Certificate of Appropriateness Application
BAR 16-01-04
512-514, 600 West Main Street
Tax Parcel 290007000, 290006000, and 290008000
Heirloom West Main Development LLC, Owner/Heirloom West Main Development LLC, Applicant
Changes of material from Approved COA

**CITY OF CHARLOTTESVILLE
BOARD OF ARCHITECTURAL REVIEW
STAFF REPORT
January 17, 2018**

Re: 510-600 West Main Street: BAR approval request for substitution of exterior cladding materials

BAR SUBMISSION FOR JANUARY MEETING
SUBMITTED: 12.22.2017

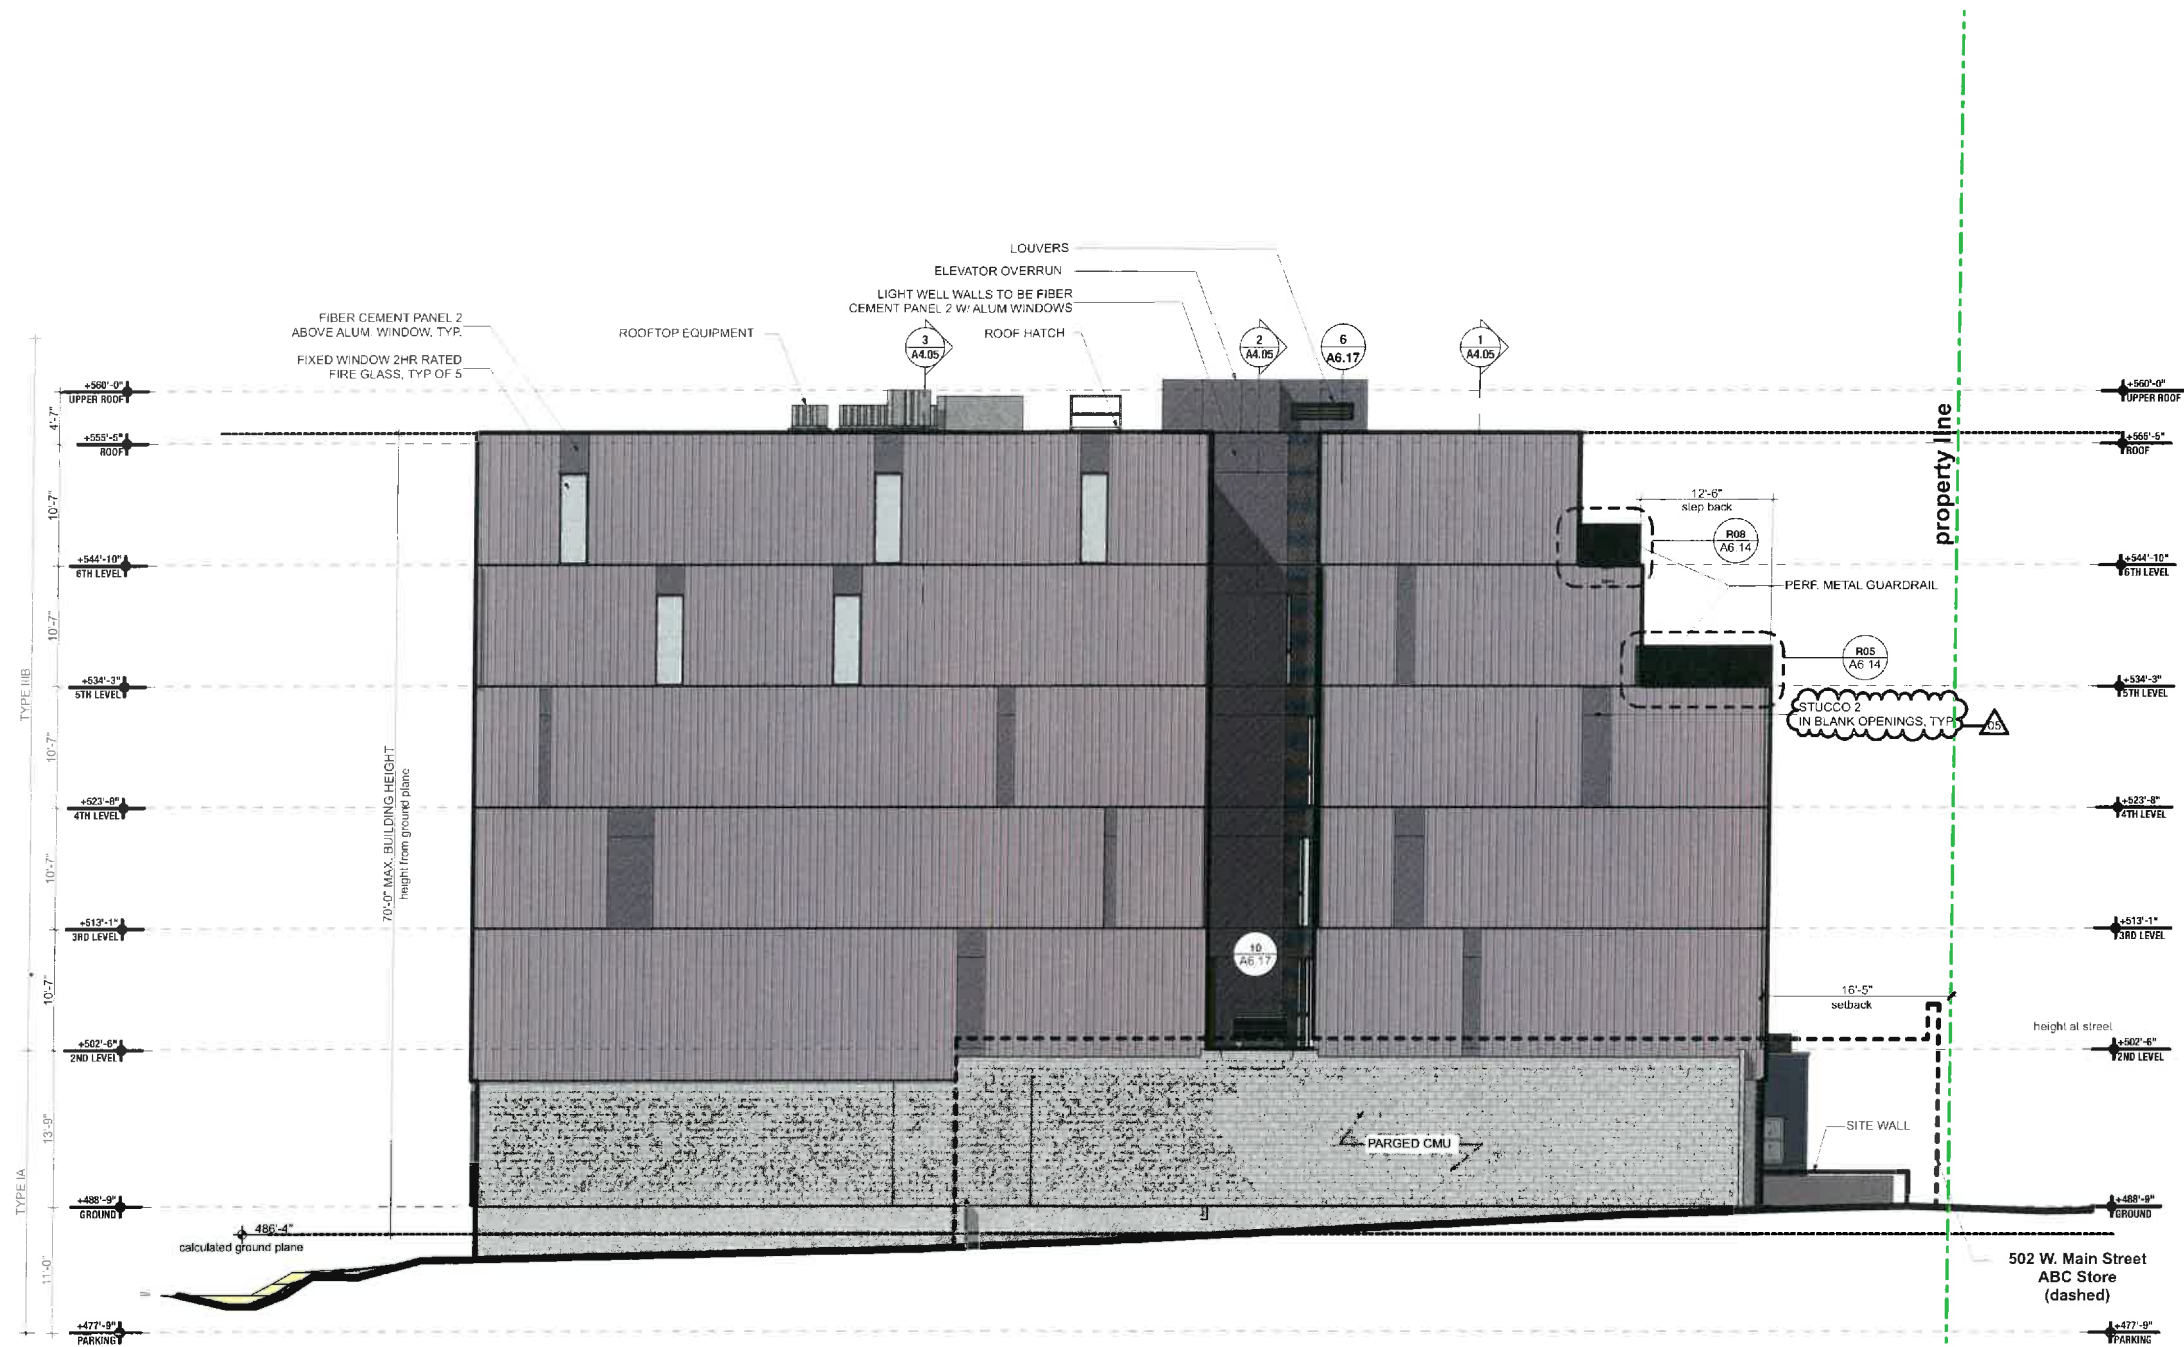
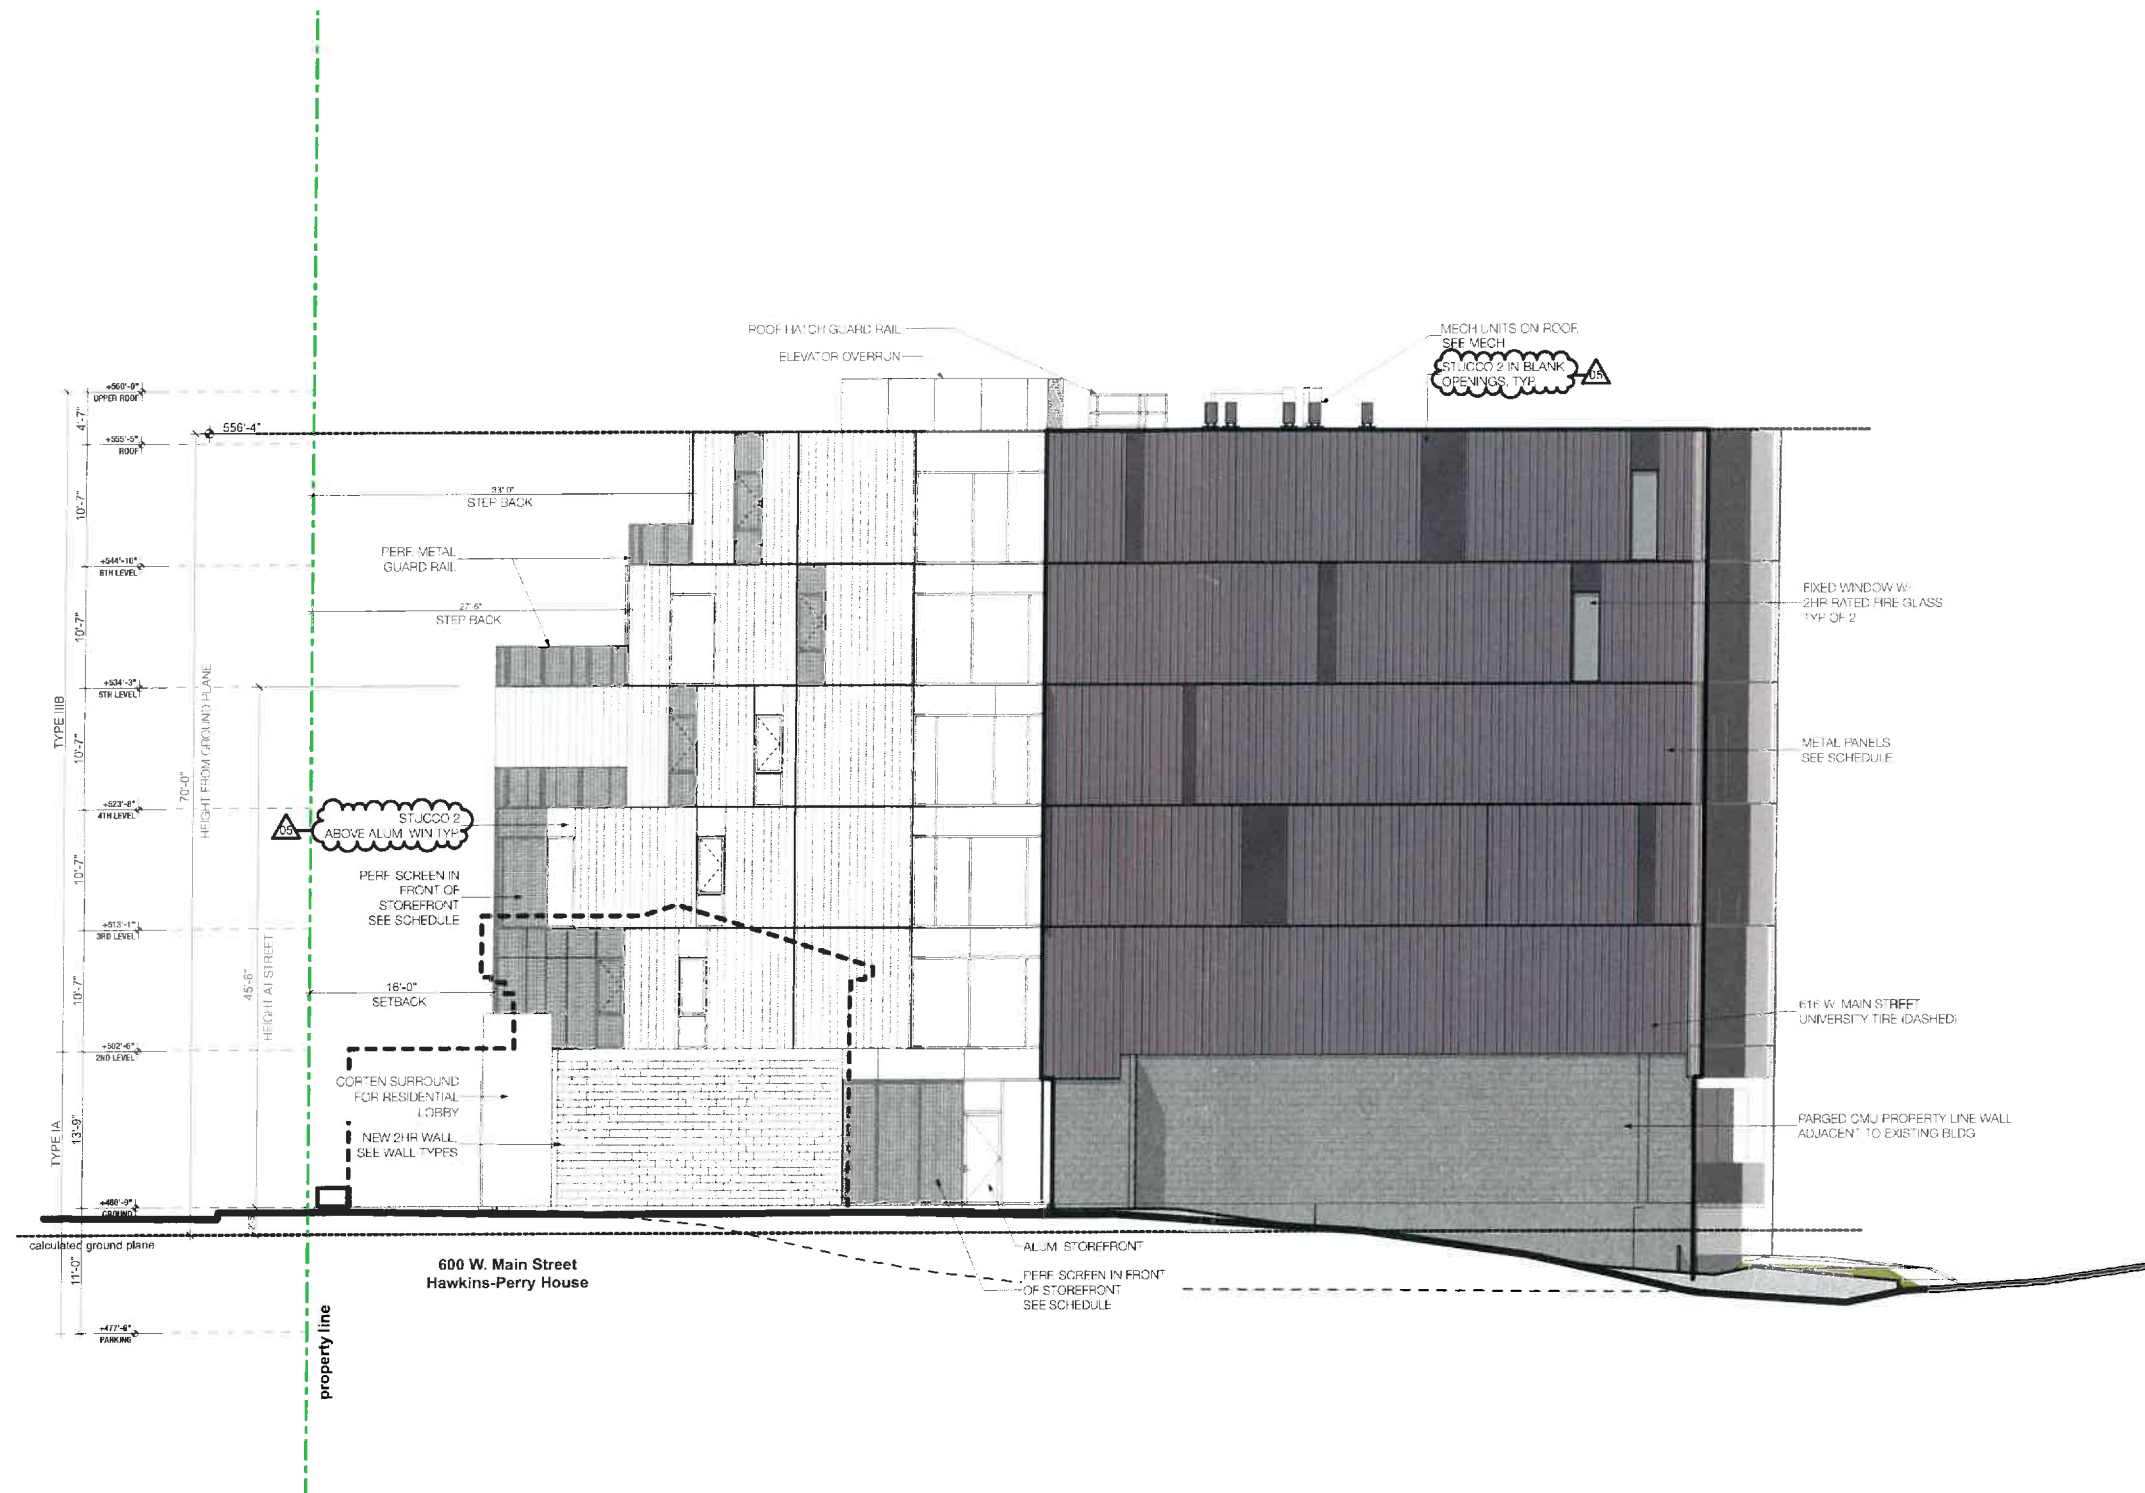
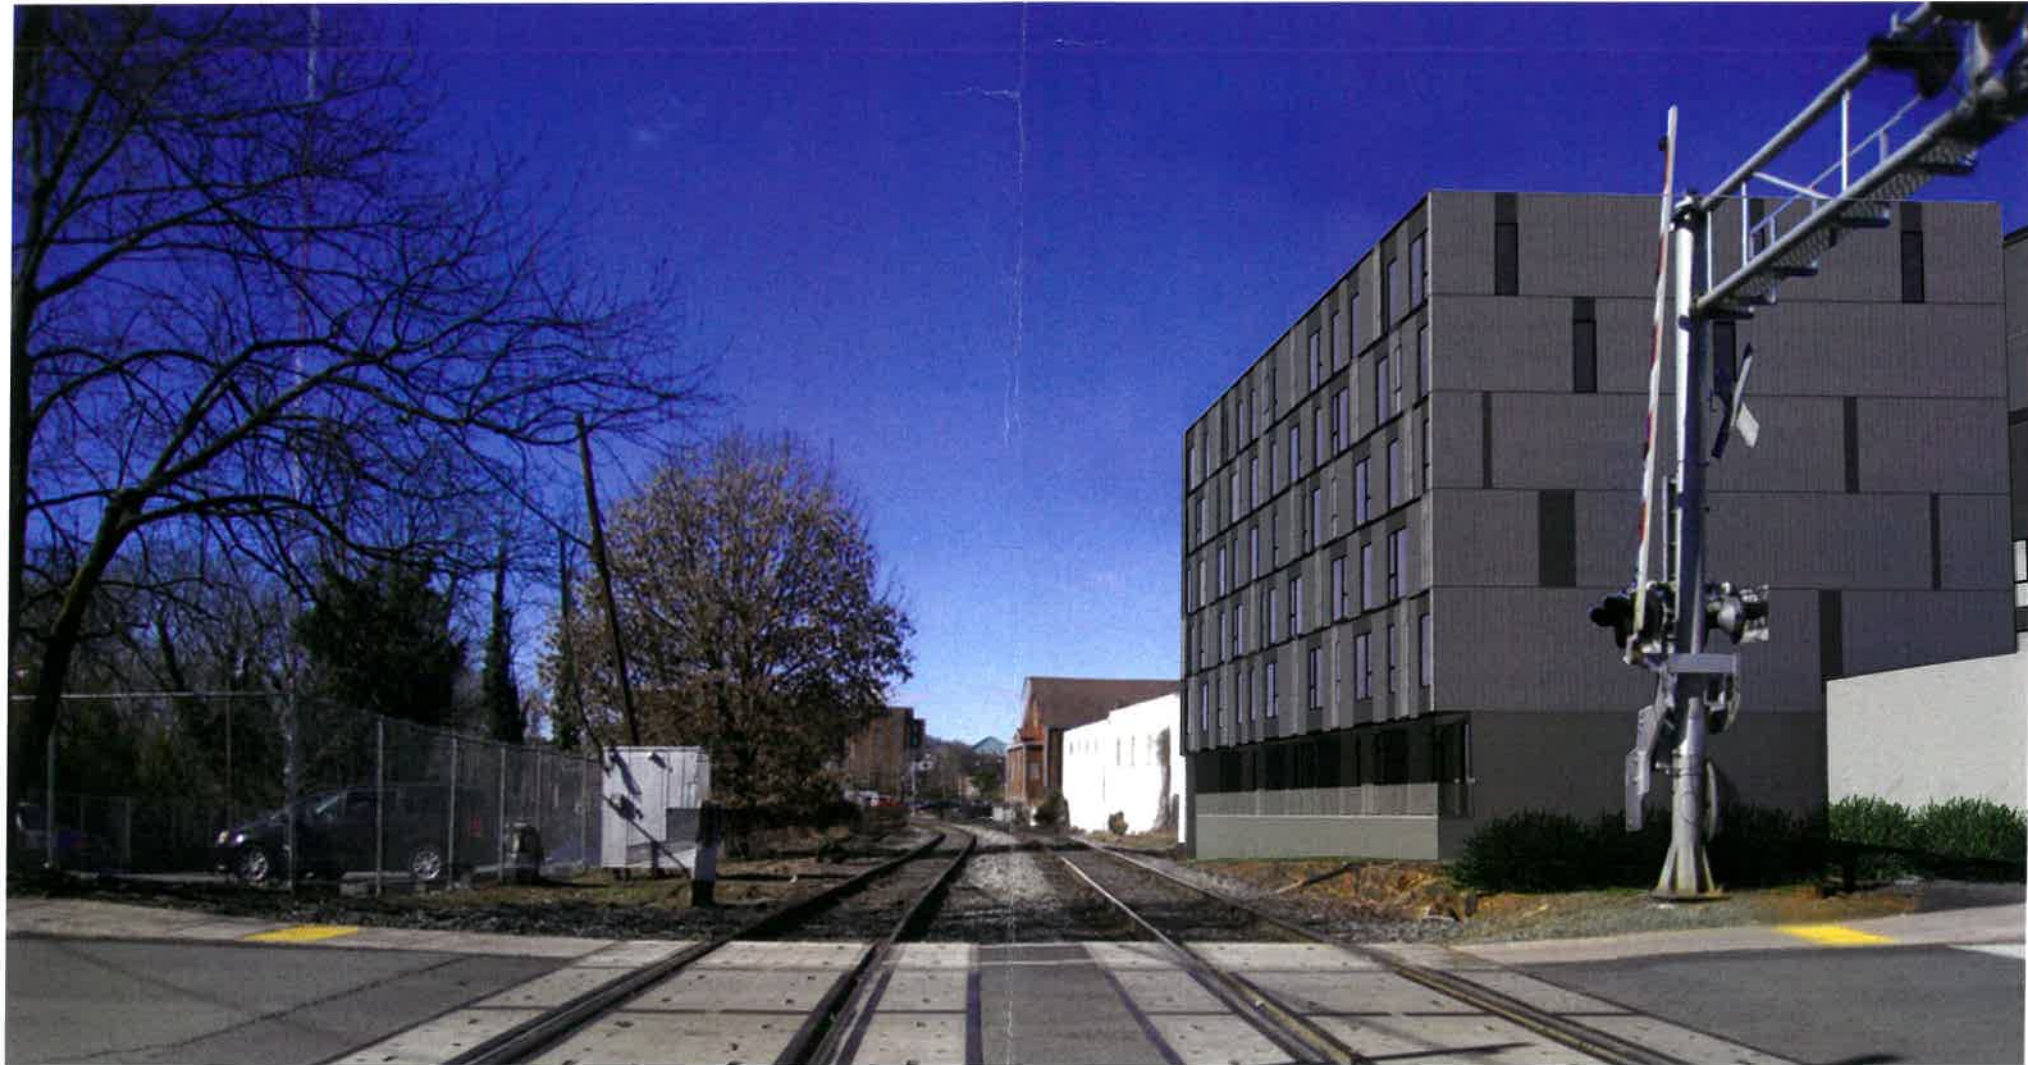
In the approved design we had a Cembonit Fiber Cement Panel material on the first floor. We propose to change this to a smooth stucco finish. This change will have very little visual impact because most of the material is under perforated screen.

- Above all windows on floors 2-6.
- In accent strips on the east and west facades.
- Underneath perforated metal screen on the street façade.
- On the south façade in two shades of grey.
- On the inward facing facades of the light well.

- The finish will be more natural and variable.
- We will be able to eliminate a horizontal joint on each floor, which was required by the Hardie Panels. This change will make the joint pattern of the southern façade more in keeping with the other sides of the building.
- The insulation will add a layer of sound absorption for the southern railroad-facing façade.

Mohr moved: Having considered the standards set forth within the City Code, including City Design Guidelines for New Construction, I move to find that the proposed amendments to the Certificate of Appropriateness satisfies the BAR's criteria and are compatible with this property and other properties in the West Main Street ADC District, and the BAR approves the application as submitted, with the request that the applicant submits design details of how the lower stucco meets the ground. Balut seconded. Approved (4-2, with Miller and Schwarz opposed.)

BAR SUBMISSION FOR JANUARY MEETING
01.17.2018

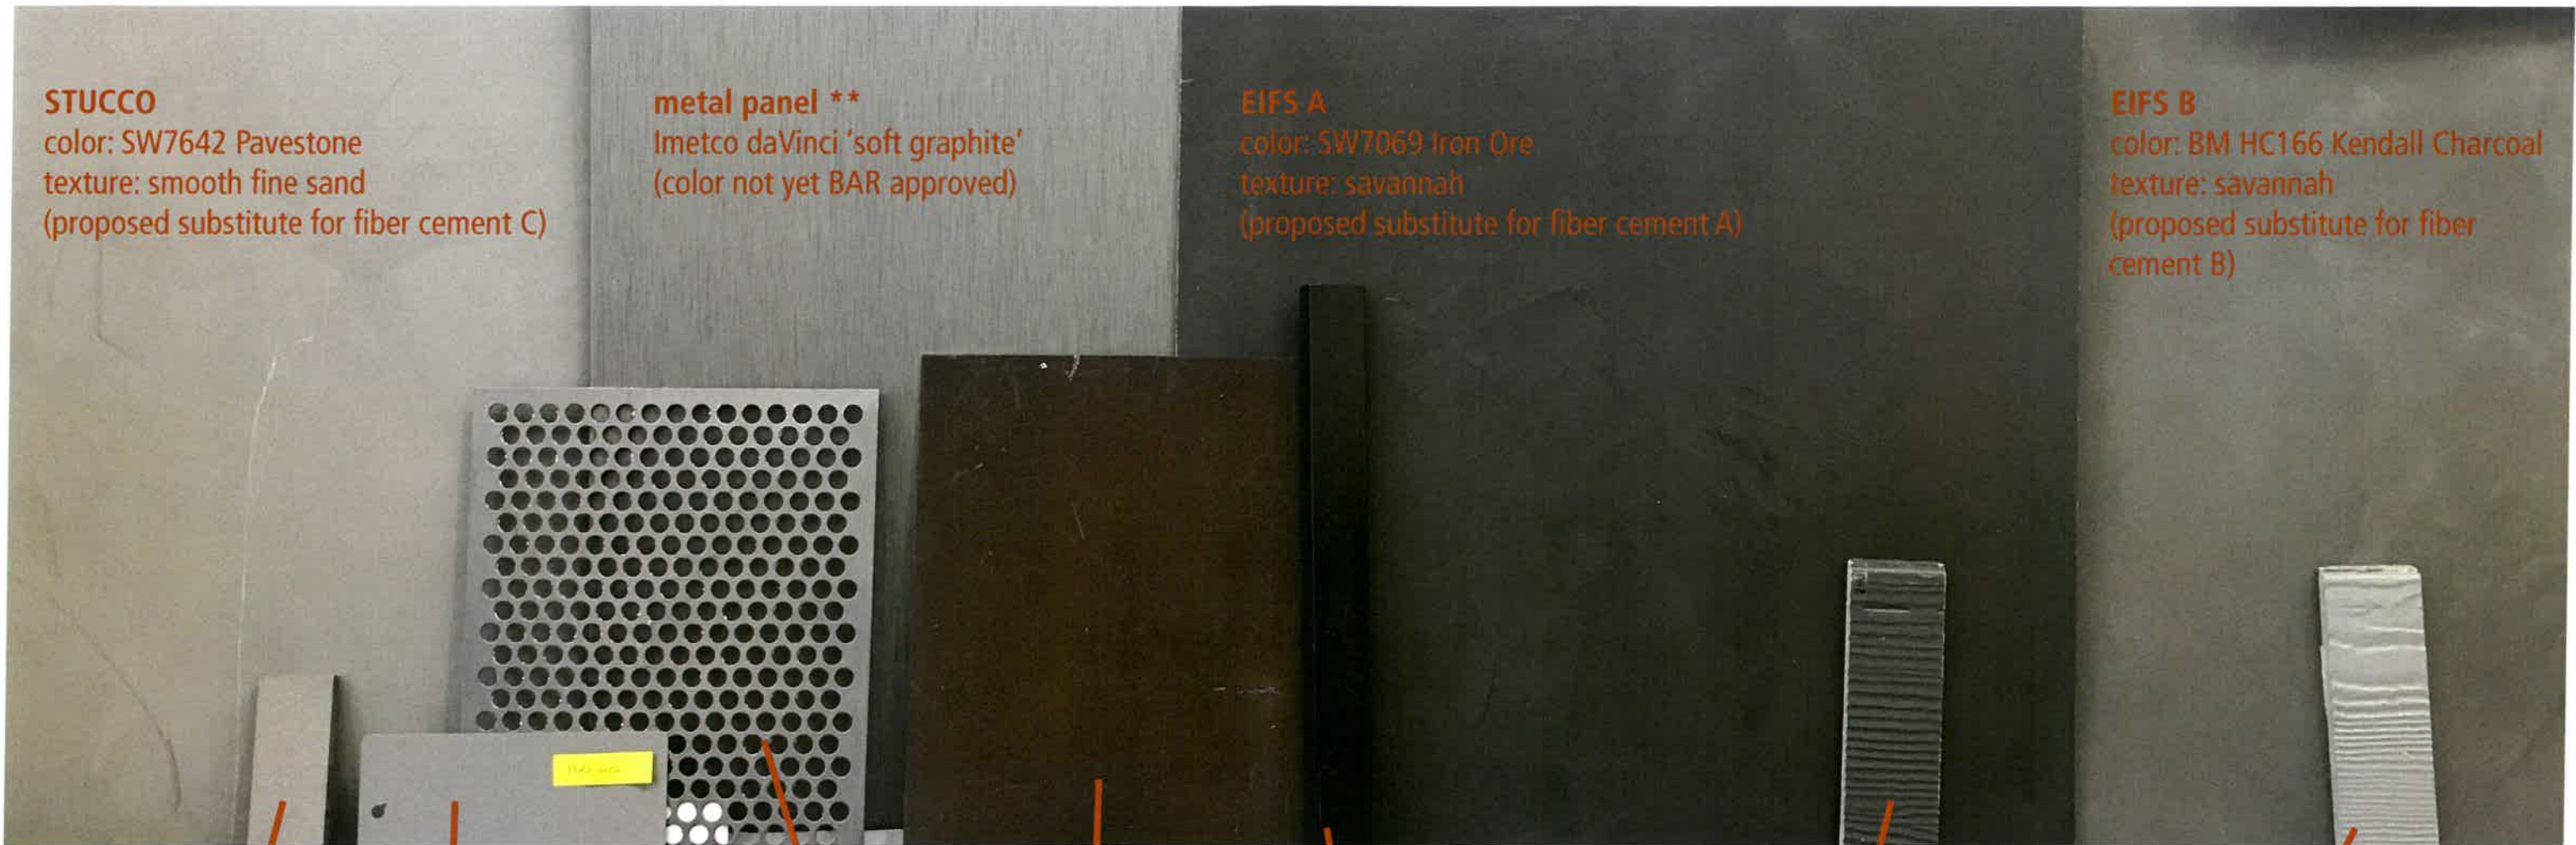
STUCCO
 color: SW7642 Pavestone
 texture: smooth fine sand
 (proposed substitute for fiber cement C)

metal panel **
 Imetco daVinci 'soft graphite'
 (color not yet BAR approved)

EIFS A
 color: SW7069 Iron Ore
 texture: savannah
 (proposed substitute for fiber cement A)

EIFS B
 color: BM HC166 Kendall Charcoal
 texture: savannah
 (proposed substitute for fiber cement B)
